Access Compliance Report

Public Rights-of-Way

(Curb Ramps)

Intersection ID: 51668	Main Street: BROWNE_RD	Cross Street: SWEETBRIAR_RIDGE_DR	Location: SE
ADA ID: 139F45FFFF09	Ramp Type: BlendTrans1	Initial Pass/Fail: Pass	Overall Compliance: No
Severity Score: 0.25			
Codes/Mitigation Info/Possible Solution		Field Measurements/Component Compliance

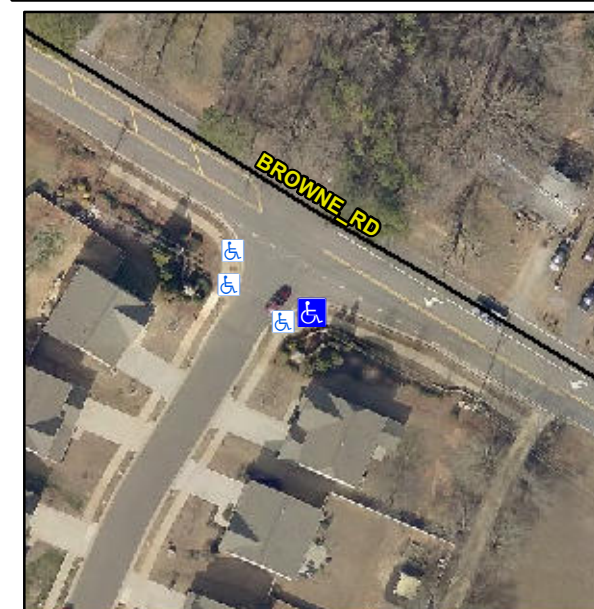
Remove & Replace Curb Ramp With Two New Directional Ramps or Equivalent. Remove & Replace Gutter.

R304.5.3, R304.2.2-Perp, R304.3.2-Para, R305.2
